# SERVICE BULLETIN

DATE: 30 JANUARY 1997  
PAGE 1 OF 6

## VSCS SYNCHRONIZATION MODIFICATION

Figure 1. VSCS Synchronization Wiring Schematic

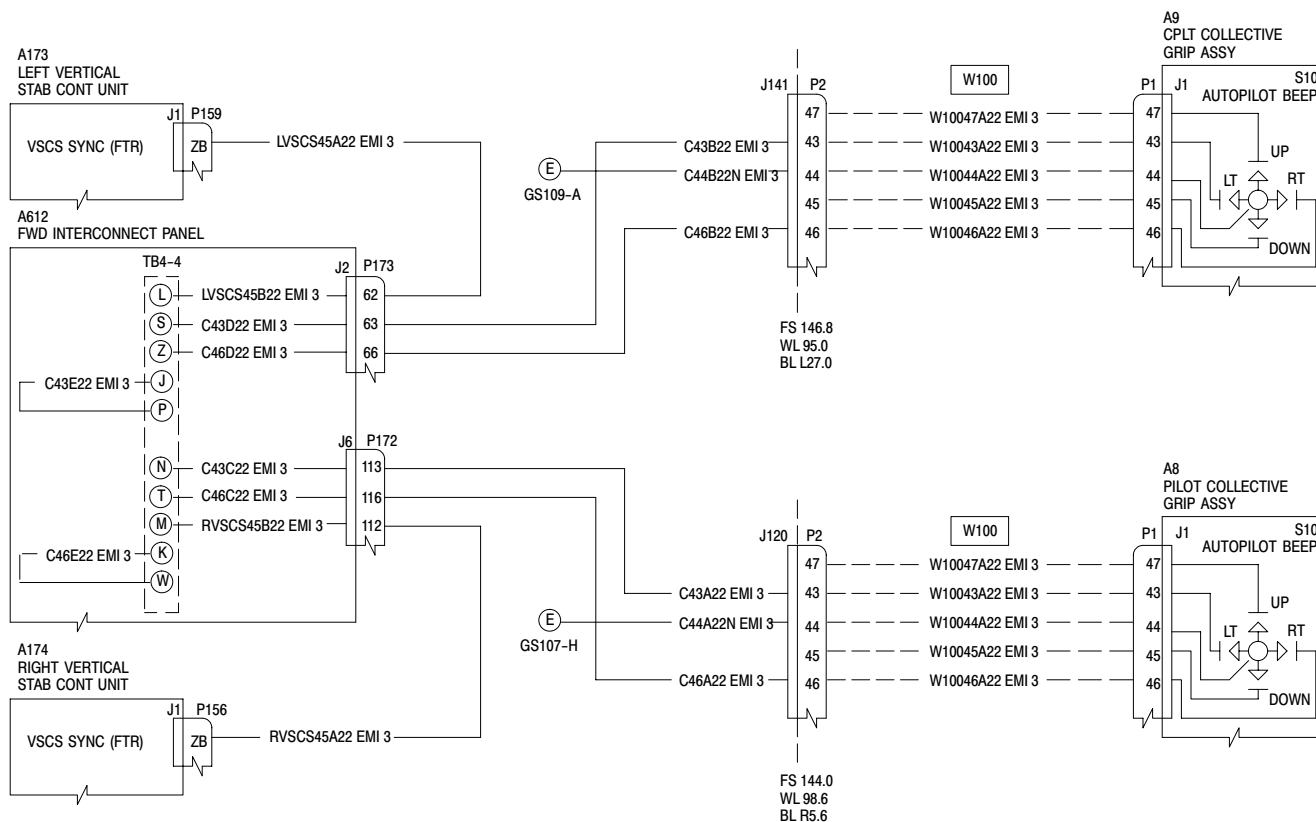
(Ref. Figure 1)

**C.** Install wires:

- 1). Install wire LVSCS45A22 EMI 3 between P159-ZB and P173-62.

**NOTE:** When installing wire LVSCS45A22, approximately six inches from P159 connector, exit EMI shield at shield extension solder sleeve. Re-enter EMI shield after passing solder sleeve. Wrap area of exposed wire with knitted wire mesh and secure with tie string.

- 2). Install wire LVSCS45B22 EMI 3 between A612 J2-62 and A612 TB4-4L.  
3). Install wire C43D22 EMI 3 between A612 J2-63 and A612 TB4-4S.  
4). Install wire C46D22 EMI 3 between A612 J2-66 and A612 TB4-4Z.  
5). Install wire C43C22 EMI 3 between A612 J6-113 and A612 TB4-4N.  
6). Install wire C46C22 EMI 3 between A612 J6-116 and A612 TB4-4T.  
7). Install wire RVSCS45B22 EMI 3 between A612 J6-112 and A612 TB4-4M.  
8). Install wire C43E22 EMI 3 between A612 TB4-4J and A612 TB4-4P.  
9). Install wire C46E22 EMI 3 between A612 TB4-4K and A612 TB4-4W.  
10). Install wire RVSCS45A22 EMI 3 between A612 P172-112 and P156-ZB.

**NOTE:** When installing wire RVSCS45A22, approximately six inches from P156 connector, exit EMI shield at shield extension solder sleeve. Re-enter EMI shield after passing solder sleeve. Wrap area of exposed wire with knitted wire mesh and secure with tie string.

- 11). Install wire C43B22 EMI 3 between A612 P173-63 and J141-43.  
12). Install wire C44B22N EMI 3 between GS109-A and J141-44.  
13). Install wire C46B22 EMI 3 between A612 P173-66 and J141-46.  
14). Install wire C43A22 EMI 3 between A612 P172-113 and J120-43.

- 15). Install wire C44A22N EMI 3 between GS107-H and J120-44.
- 16). Install wire C46A22 EMI 3 EMI 3 between A612 P172-116 and J120-46.
- 17). Tie all added wires into existing wire harnesses.
- 18). Reinstall any removed components.
- 19). Close all opened panels.
- 20). Using indelible ink, identify the A612 forward interconnect panel in the area of the part number with the number of this Bulletin.
